Re: Initial Submission Review – Murphy Creek PA 16 & 20 – Site Plan w/ Adjustments, Plat
Application Number: **DA-1250-48**
Case Numbers: **2020-4020-00**

Initial Submission Review

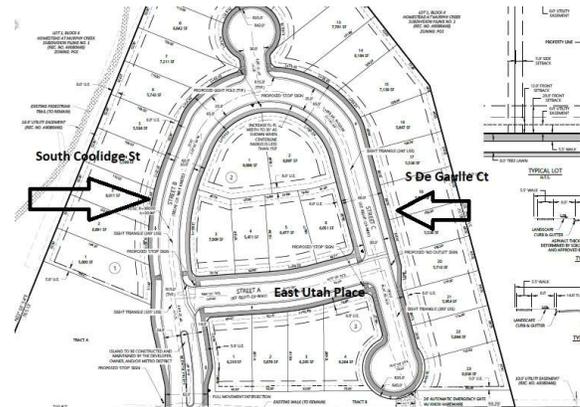
5O. Provide information for the front yard landscape requirement. Are there various lot sizes? if so, the site may need to be broken down into A, B, C lots etc. Sod is not permitted in the front yards unless it is 400 contiguous sf. Provide a table that accounts for the number of shrubs/grasses etc. that are to be provided. An example may be provided upon request.

Response: A front yard landscape chart has been provided in accordance with the Murphy Creek GDP and UDO.
